# Staff Report

**Item:** 120 [N.] Arney Rd, "Holiday Inn Express" addition/remodel (DR 22-17)

Design Review DR 22-17 (Type III) for proposed site redevelopment of the La Quinta Inn & Suites by Wyndham Woodburn motel through addition and remodel into a Holiday Inn Express (HIEX) with site upgrades and Street Adjustment SA 22-09 for an Arney Road landscape strip six inches narrower than the standard: Commission decision.

Figure 3.05C - Parking Space Striping

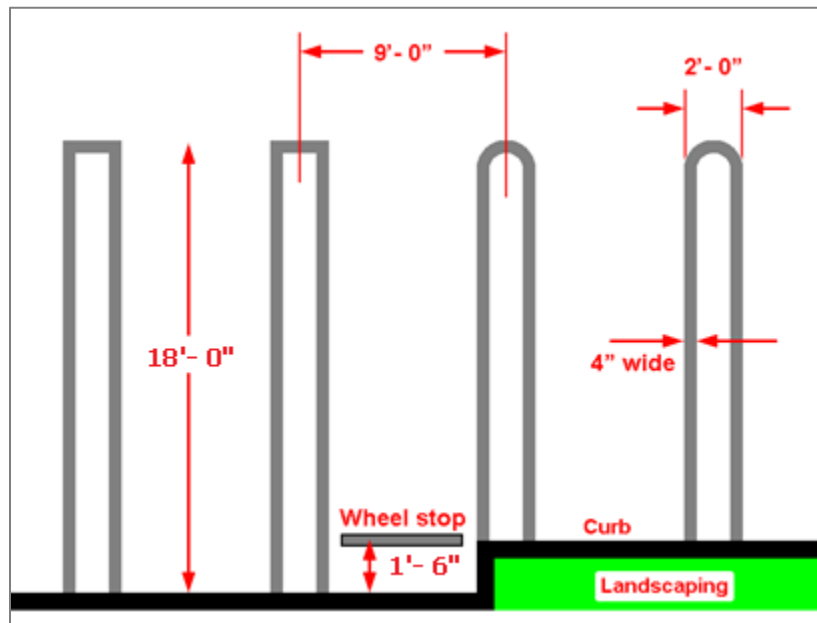
The applicant proposes all stalls, which are all at 90° to the drive aisle with dimensions and curbing that meet or exceed the minimum. Regarding double-striping, the site plan represents conventional single stripes, and no obvious call-out or note indicates double-striping per Figure 3.05C, confirming that the developer likely would have striped single-stripe stalls, necessitating resolution prior to building permit issuance to have correct striping.

D6. Double-striping: To conform with WDO Figure 3.05C, the developer shall revise the site plans prior to building permit issuance and double-stripe parking stalls.

**SITE PLAN**

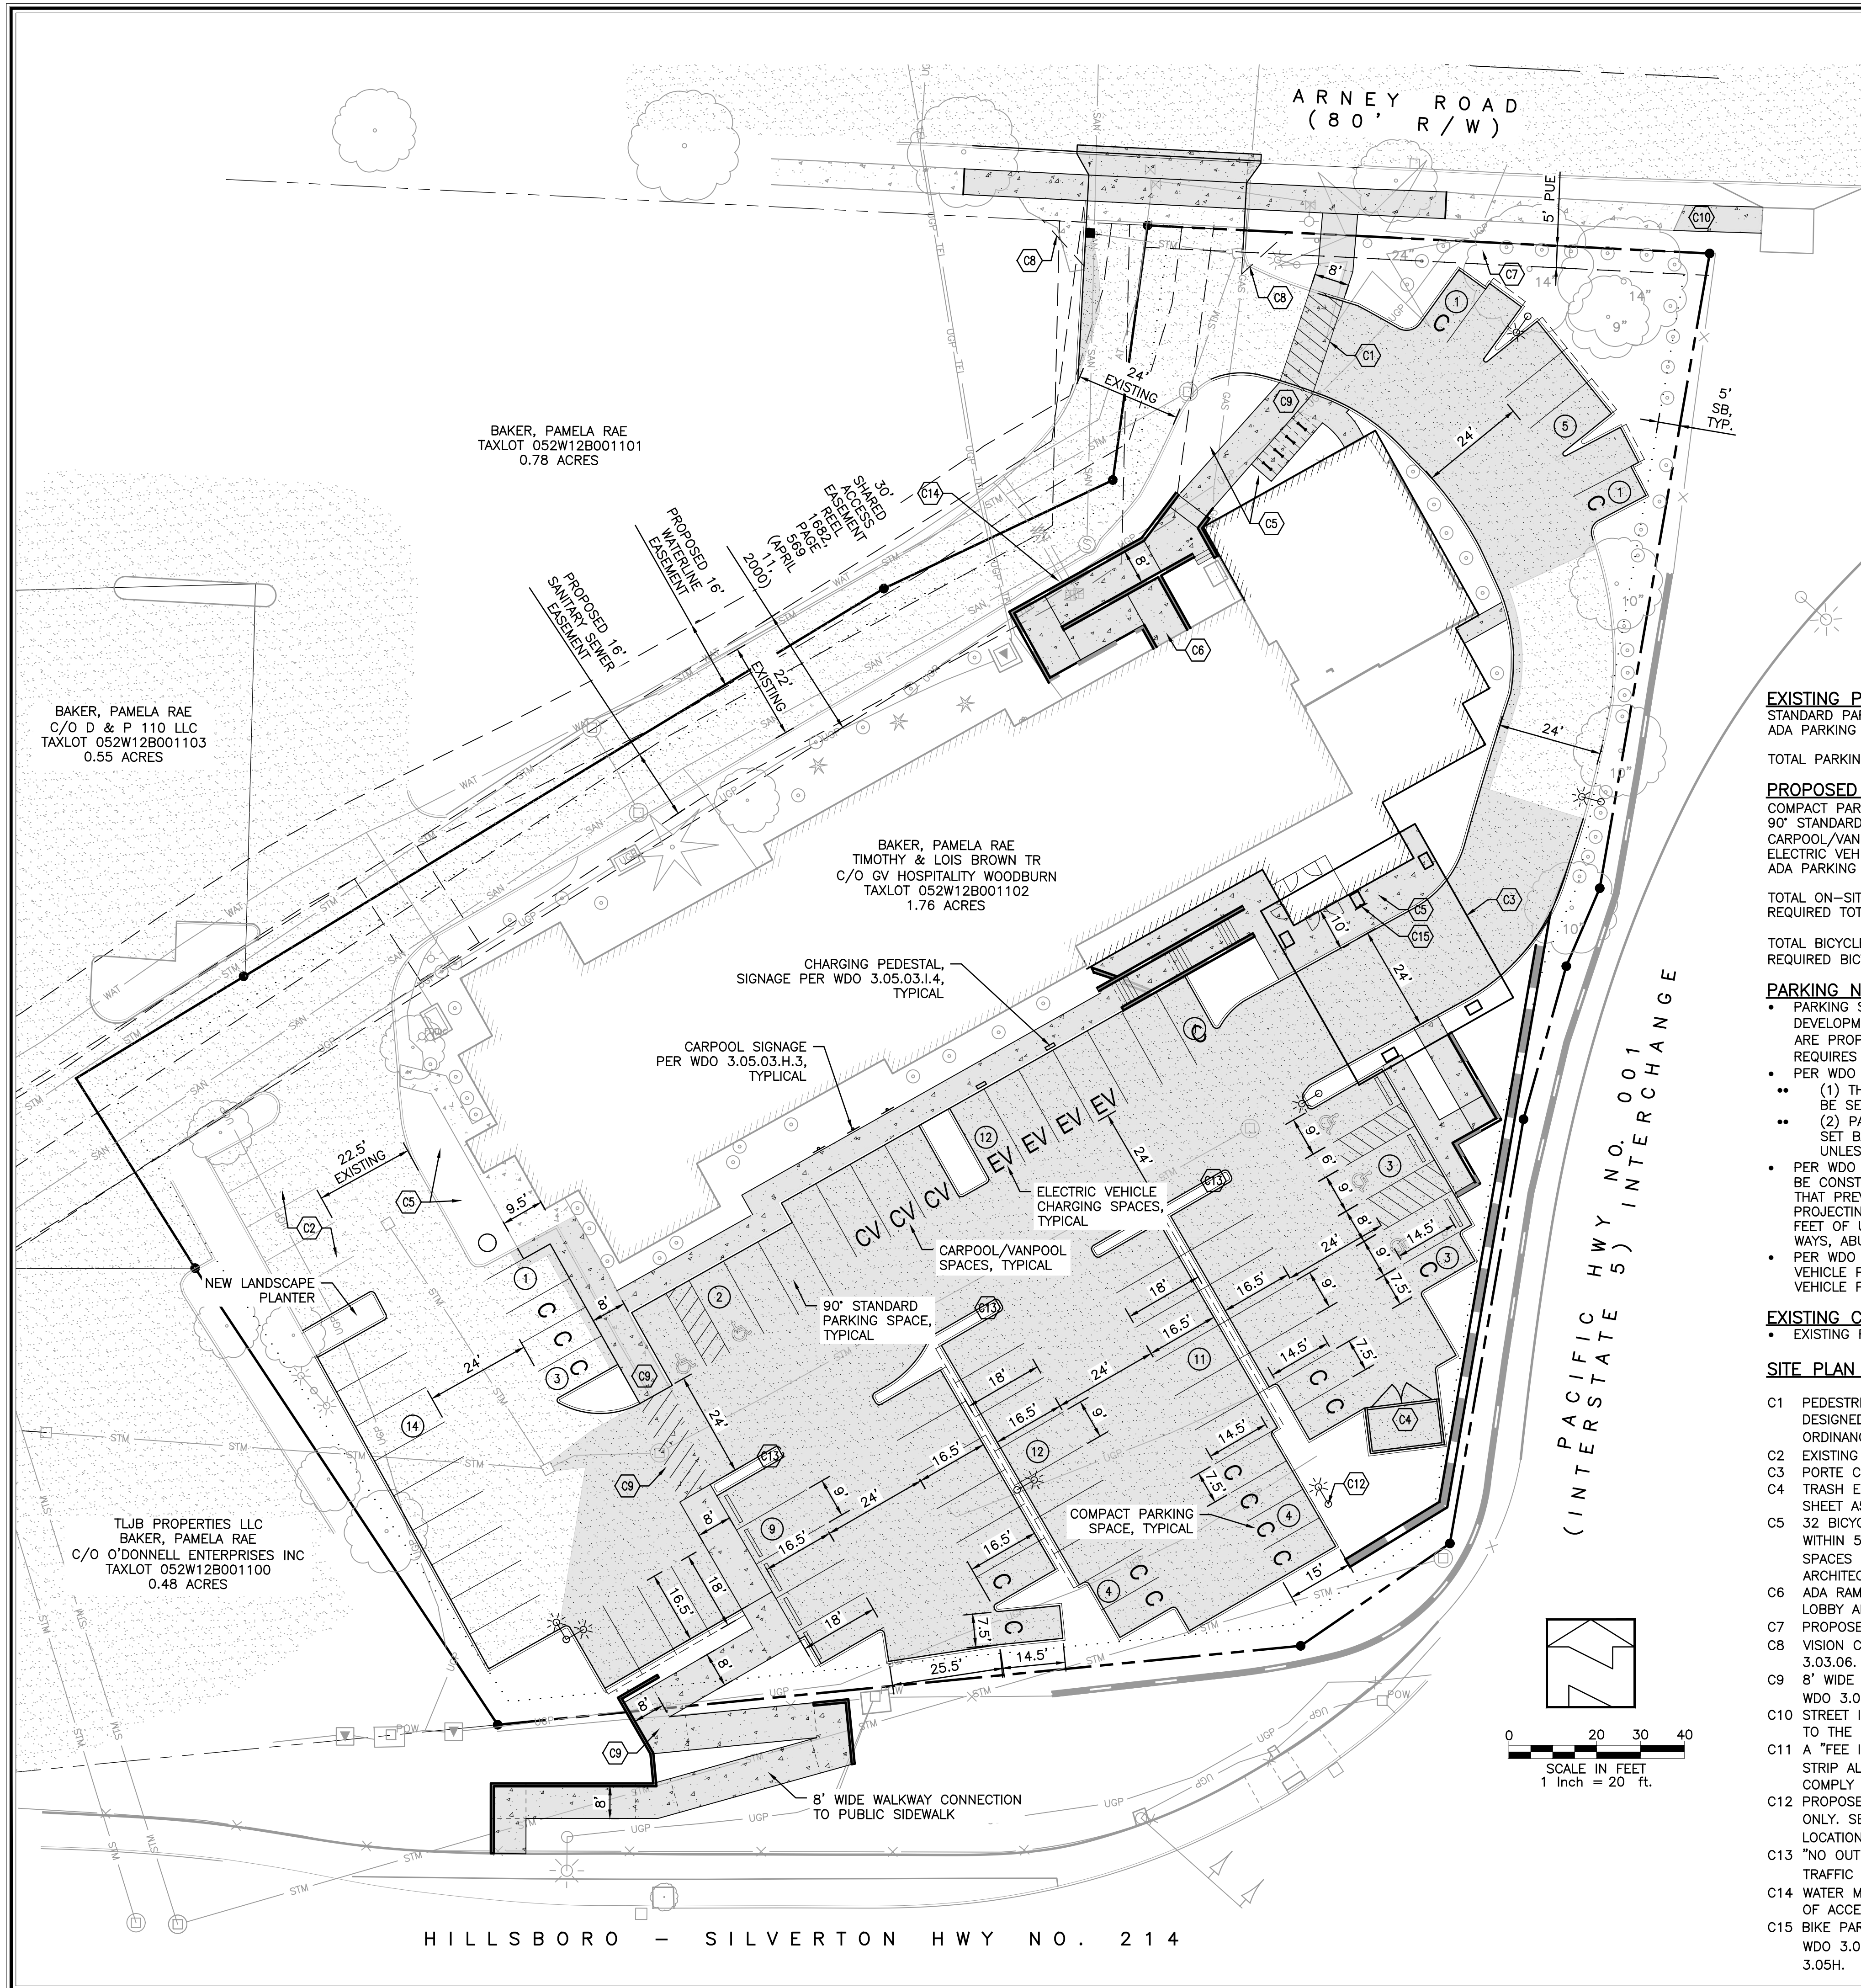
D2. Driveway max width: To conform with WDO Table 3.04A maximum regarding paved width of two-way driveways in a commercial context, the developer shall revise the site, composite utility, and landscape plans – or equivalent sheets within a building permit application plan set through the Building Division and/or a civil engineering review application civil plan set through the PW Engineering Division (and/or ODOT if and as applicable) – either to illustrate and dimension the approach, apron, curb cut, or ramp of the Arney driveway at max width 24 ft or, if having a left turn pocket, then 36 ft; or, to document if and how Table 3.04A footnote 7 about Woodburn Fire District (WFD) OFC administration is applicable. For the latter, documentation shall include at least either (a) a letter or equivalent from WFD or (b) revision of fire access plan Sheet P220 to narrow the driveway to that necessary to accommodate illustrated fire apparatus turning radius and to dimension the narrowed driveway apron. If through building permit review, then this is due prior to issuance, or if through civil engineering plan review, then due prior to PW (or ODOT) issuance of an approved civil plan set.

D3. Walkways: To conform with WDO 3.04.06D.2, the walkway crossing of the drive aisle near the main guest entrance and ADA parking shall be striped with any of hatch or ladder pattern or three or more bars perpendicular to the crossing. The developer shall revise site plans prior to building permit issuance.

D4. Wheel stops: To conform with WDO 3.05.02H, the developer shall revise the site plans prior to building permit issuance and install wheel stops in the two compact parking stalls along the highway wide walkway north end.

- b. Significant tree:
  - (1) To conform with WDO 3.06.07, the developer shall revise the site, composite utility, grading, and landscape plans to note protection of the 24-inch cedar tree during construction of Arney wide walkway to its west and additional parking to its east.

Landscape plan (Sheet P400 excerpt colored by staff; walkways in brown)

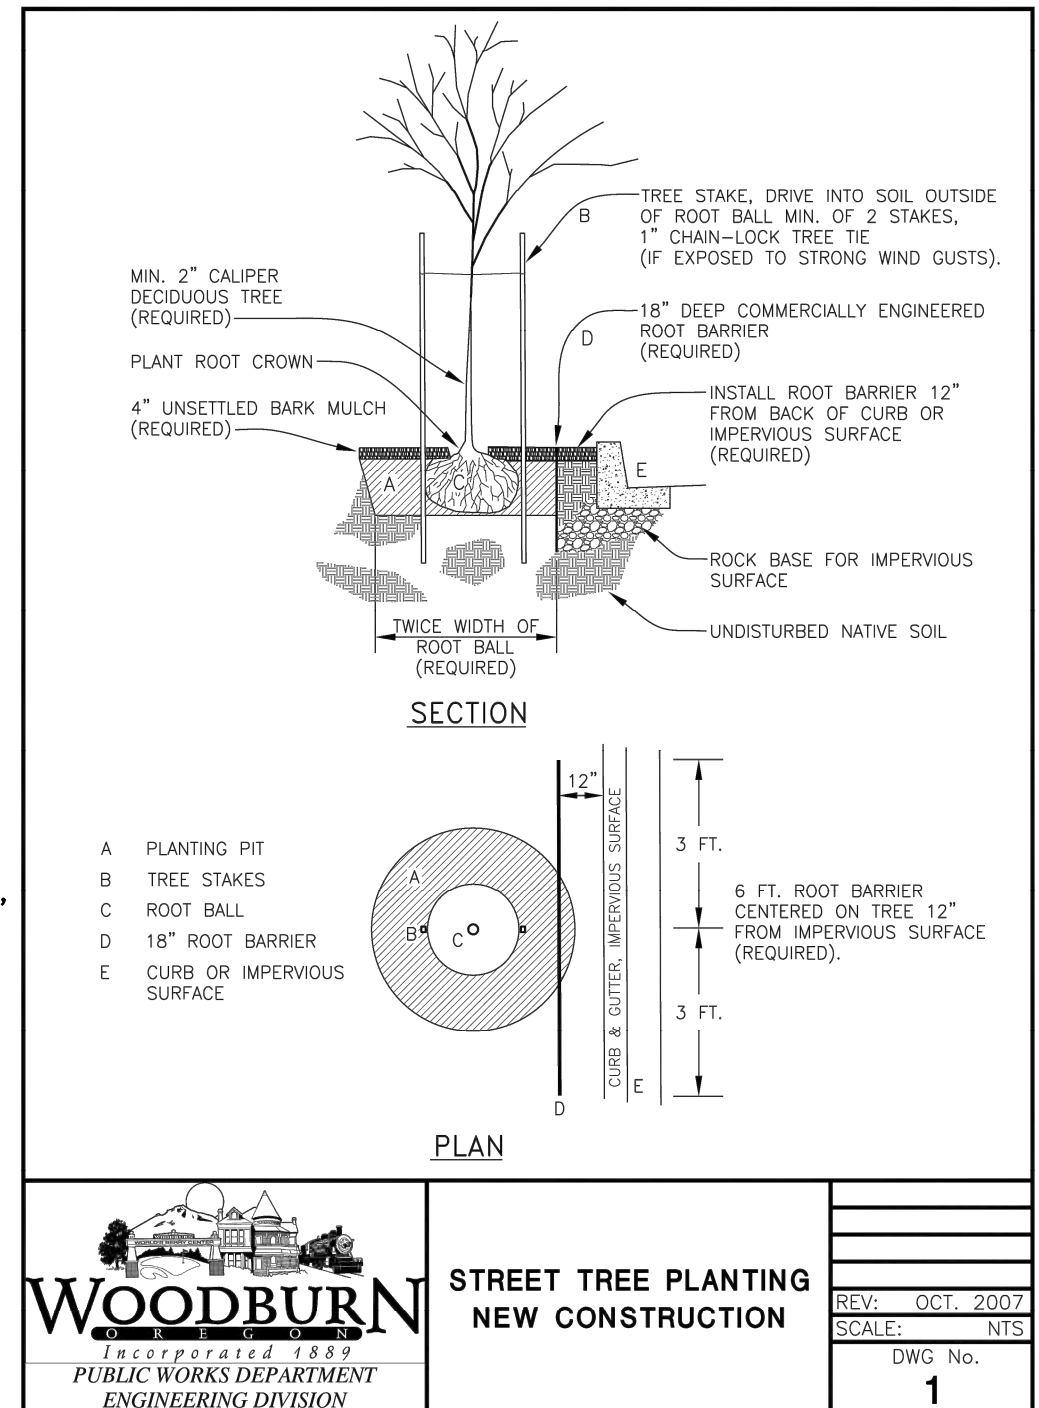
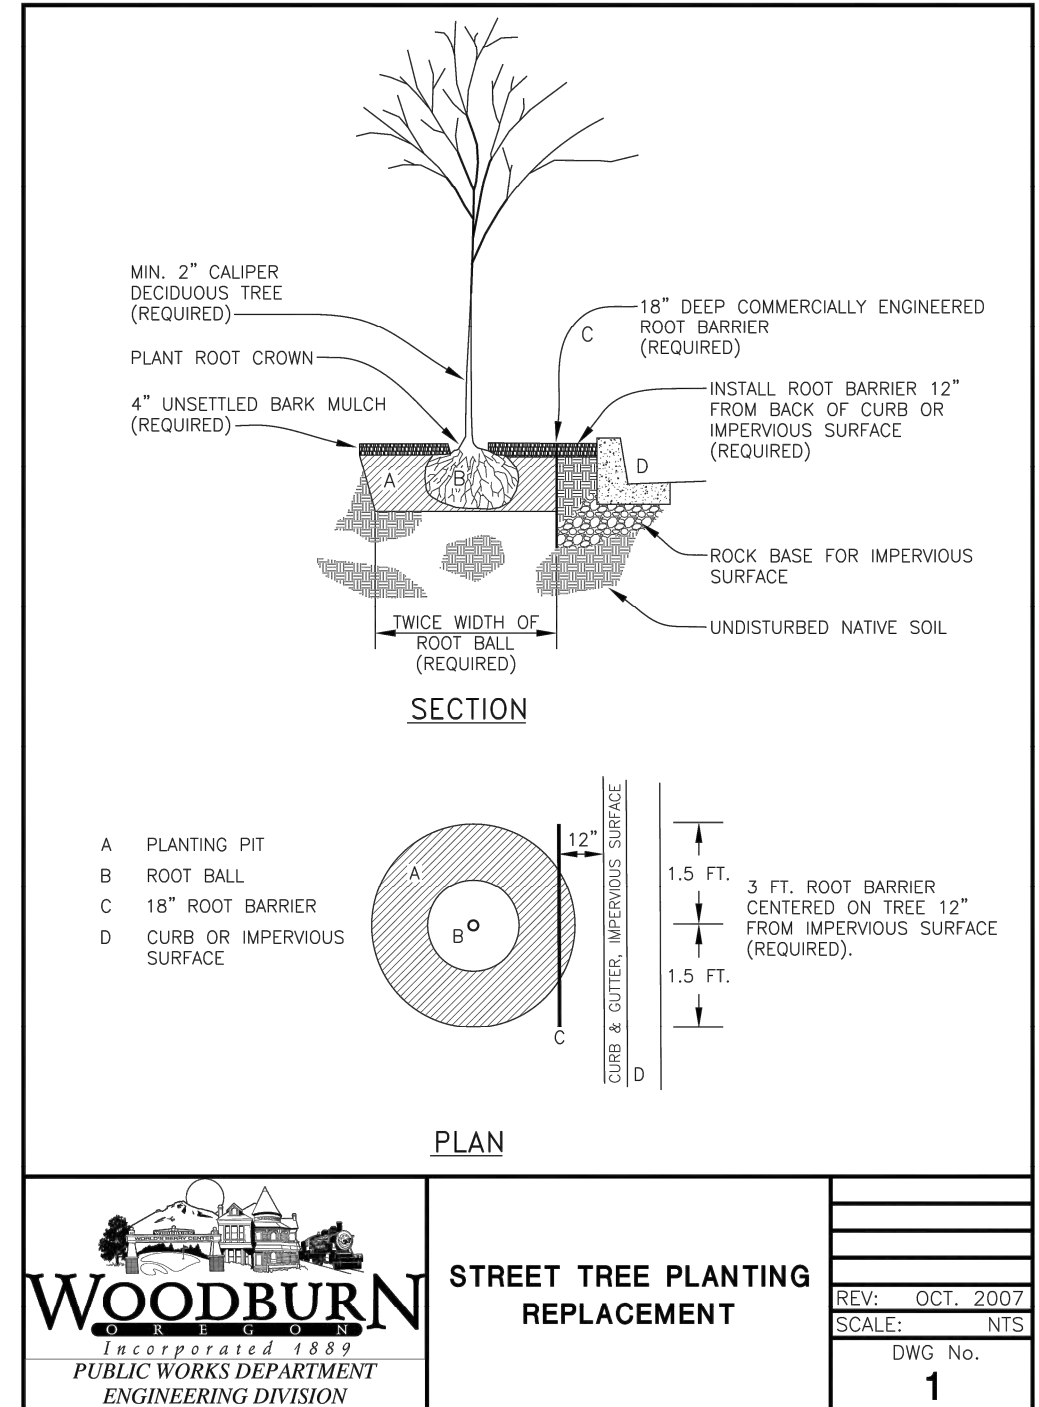
- a. Arney: Plant for 4 trees or pay a fee in lieu of max 1 tree per Attachment 202.
- b. OR Hwy 219: Plant for 8 trees or pay fee in-lieu per Attachment 202 and as follows:
  - (1) Landscape strip: Plan min 2 of the 8 trees; and
  - (2) Wide walkway: Do one of the following in order of preference:
    - (a) Plant 2 trees outside the landscape strip but within the ROW at the approximate locations per Exhibit SA2 below with the objective to shade the wide walkway from the west;
    - (b) Plant 1 of the 2 trees per (a); or
    - (c) If ODOT makes infeasible planting per (a) and (b), then no planting within this area of ROW.
